**Village Plan Commission
Meeting Agenda
Monday, October 10, 2022
5:30 P.M.**

TO: Intergovernmental Agreement (IGA) Joint Commission & Village of Somers Plan Commission
FROM: Luke Godshall, Senior Land Use Planner
RPT DATE: 09-27-22
MTG DATE: 10-10-22
RE: Somers Bobcat

SITE DIMENSIONAL & PAVING PLAN

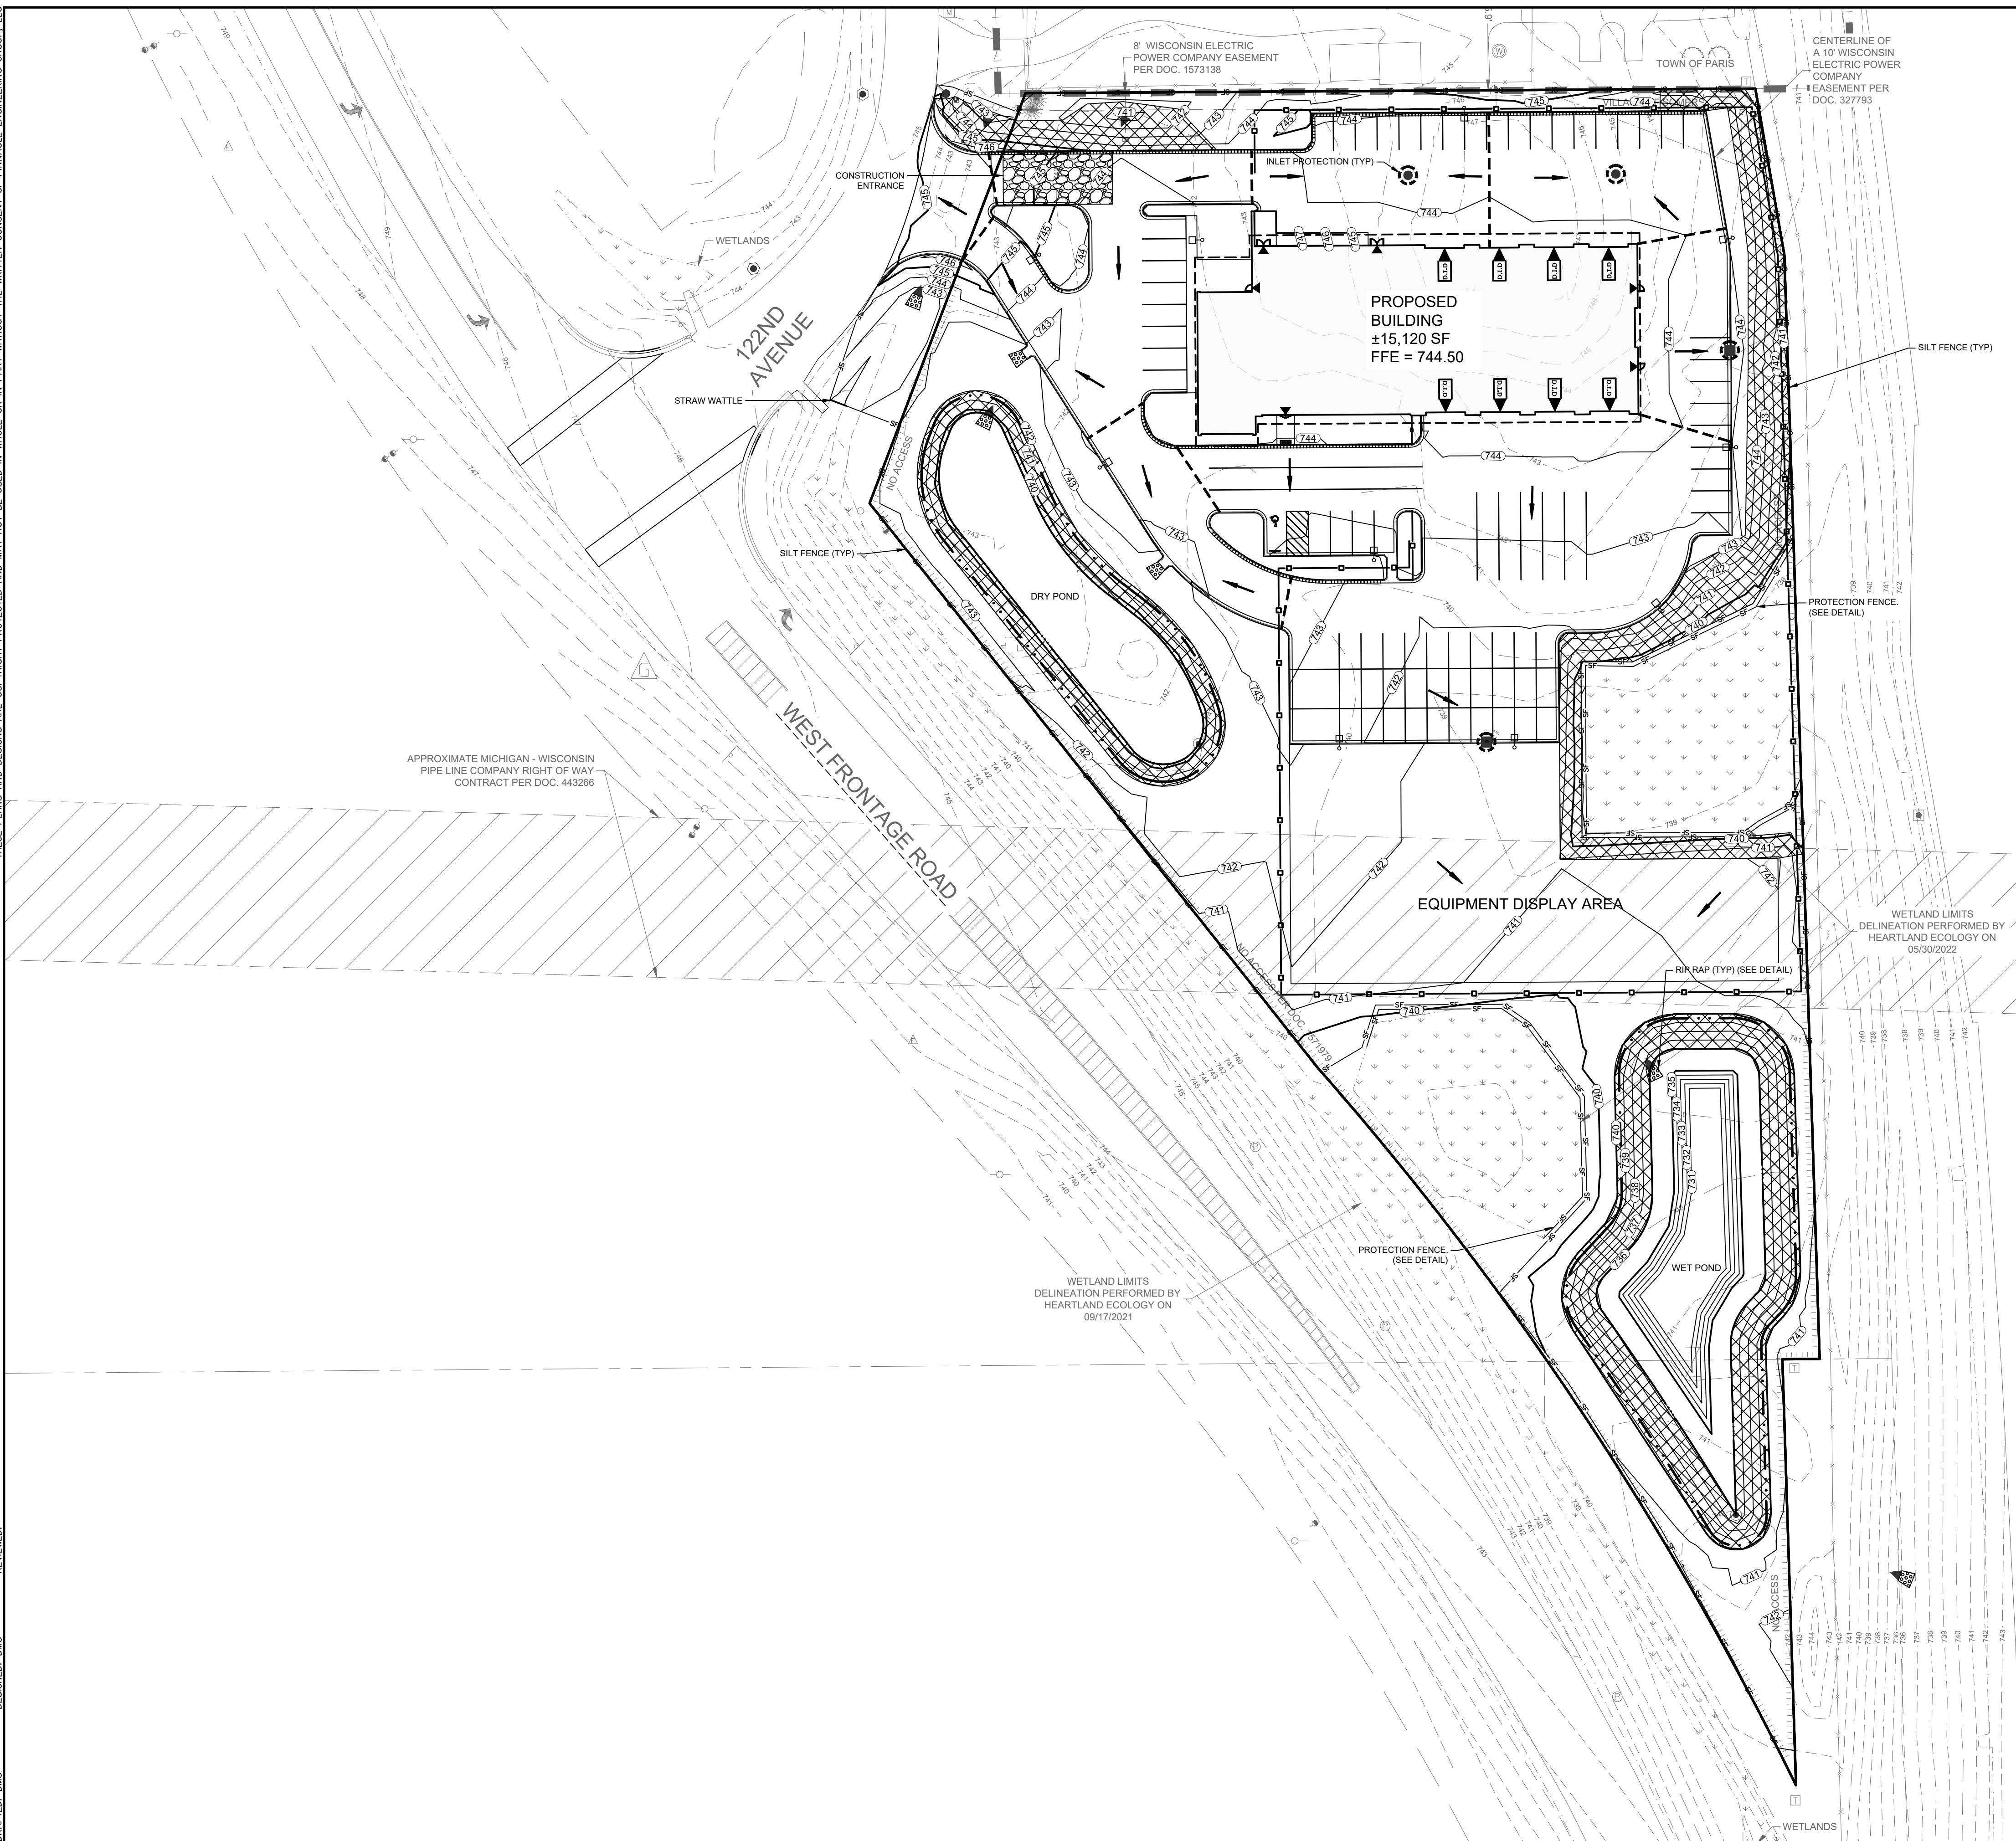
The site plan indicates that a fence will surround the equipment display area and outside vehicle/equipment storage areas on the north, east and south sides of the building. However, no details are provided on the submitted plans regarding the height or composition of the fence. The site design standards contained in the I-94 Corridor Neighborhood Plan indicate that outdoor storage areas shall be screened from view of any public street right-of-way, public park or public open space area, and from the view from all residential areas. Solid walls or fences shall be a minimum of 8 feet in height. Details of the proposed fence enclosing the outside storage areas will need to be provided.

The submitted site plan shows a total of 13 customer parking stalls being provided. Under the Somers zoning ordinance, the number of off-street parking stalls required for "Automobile sales or rental, farm equipment sales or service" uses are 1 space for every 100 sf, plus 1 space per 500 sf of outdoor display area. The Petitioner is proposing a building of 13,325 sf (133 spaces), and an outdoor display area of approximately 19,000 sf (38 spaces) – for a total of 171 spaces required by ordinance. It is recognized that applying this standard to the subject site would not be feasible. Therefore, it is suggested that the IGA Joint Commission & Village of Somers Plan Commission allow the Petitioner to submit evidence and documentation as provided for under Section ZN 3.06(3)(d) of the Somers zoning ordinance to show that adequate parking and unloading areas will be provided for customers, clients, visitors, and employees and that the proposed operation requires less parking than the ordinance requires. In light of concerns brought up by the IGA Joint Commission at the conceptual hearing in August, it is reiterated that all customer parking, loading, unloading and/or parking of trailers must be provided on-site and in no case shall any parking, loading, unloading and/or parking of trailers occur within any road rights-of-way.

Because the proposed use borders a neighboring residential use to the north, the Somers zoning ordinance requires a parking surface setback of 20'. The Petitioner is requesting relief from this standard to allow a 10' parking surface setback from the north lot line through a PUD Planned Unit Development Overlay request.

There is a gas pipeline easement running through roughly the middle of the property in an east-west direction. The submitted site plans show a major portion of the proposed equipment display area and fencing located within the easement area. At this time, it is unknown if the pipeline will allow these improvements to be located within the pipeline easement. The Petitioner has indicated to staff they are in communication with the pipeline and have so far received only a verbal approval pending further review by the pipeline. If approval by the pipeline is granted, it is recommended that written

documentation be provided. If the pipeline does not grant approval, the site plan will need to be revised to remove/relocate the improvements from the pipeline area.

6. The Petitioner shall provide details regarding the proposed outside storage area fence enclosure, particularly fence height and type (material) of fence to be installed.

SHEET
L-1
 L-4
 PEG JOB No. 2402.00A
 MTS
 START DATE 07-18-24
 SCALE 1" = 40'
 © COPYRIGHT 2018

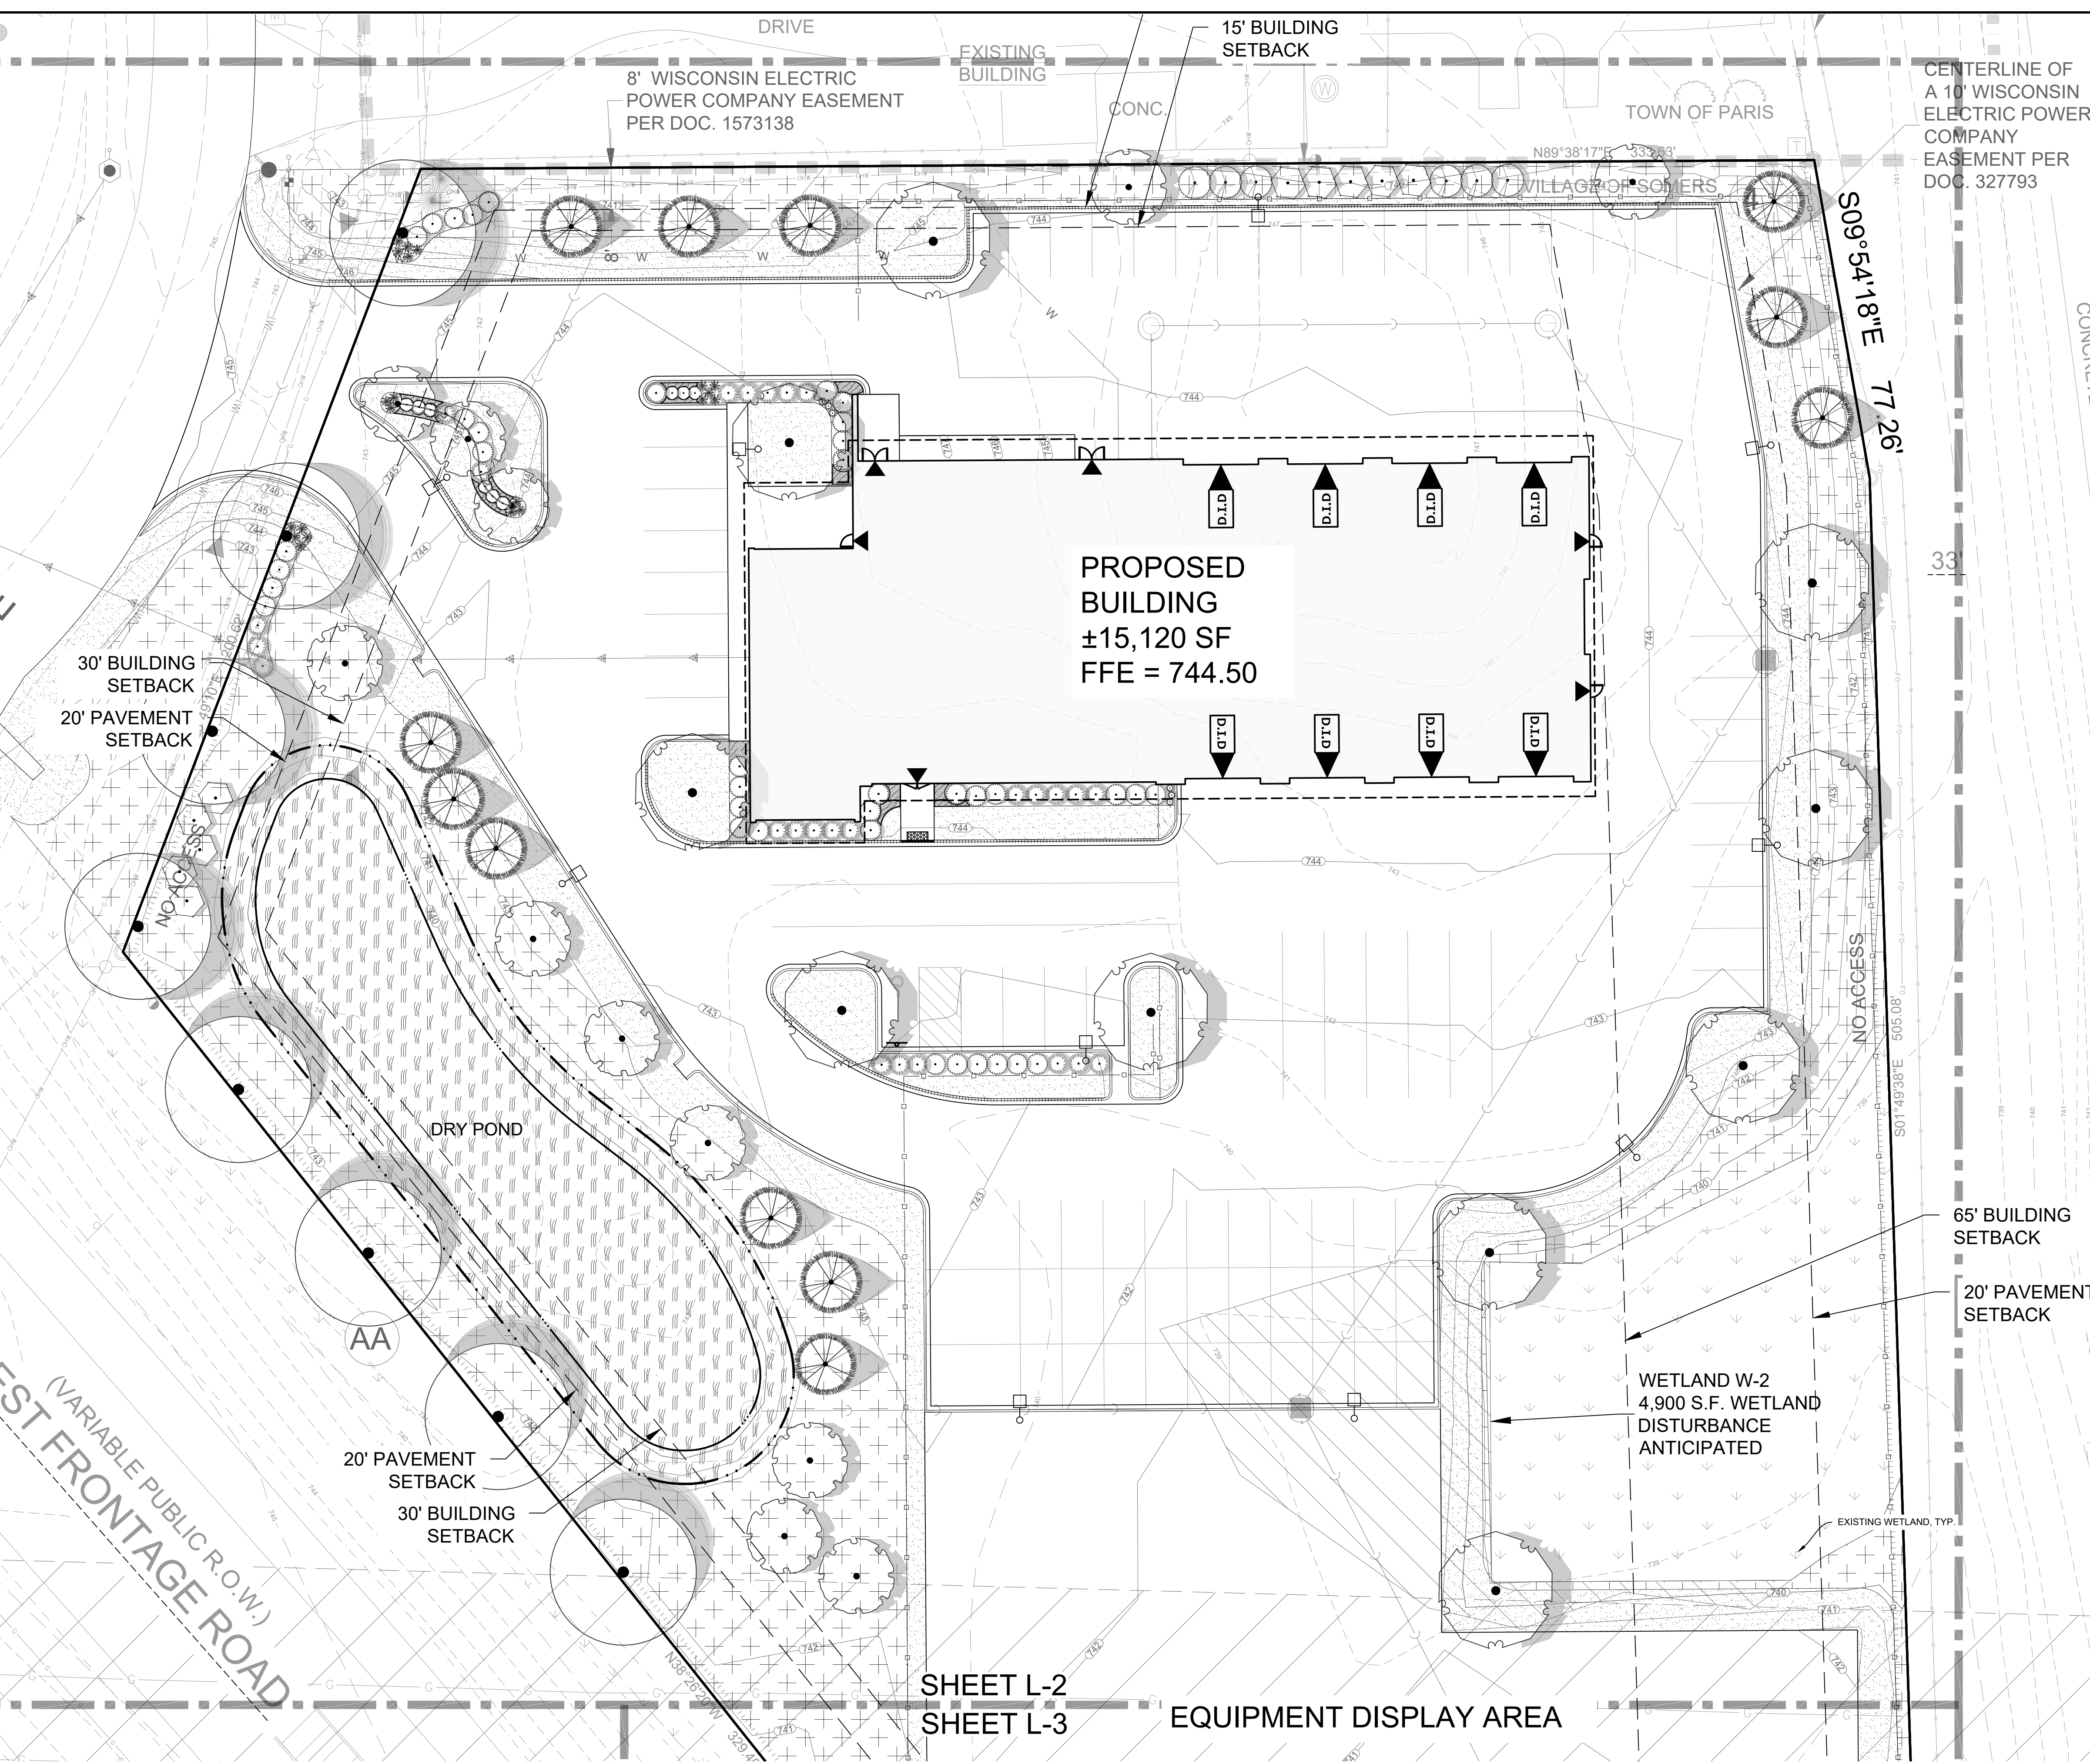
The submitted landscaping plan (sheets L-1 through L-4 dated 7-18-22 by Pinnacle Engineering Group) shows compliance with Village of Somers zoning ordinance requirements. The plan meets the minimum open space requirements of both the I-94 Corridor Neighborhood Plan (25% requirement) and the Village of Somers (15% requirement). The submitted plans indicate 52.7% of the site (2.28 acre) is contained in green space.
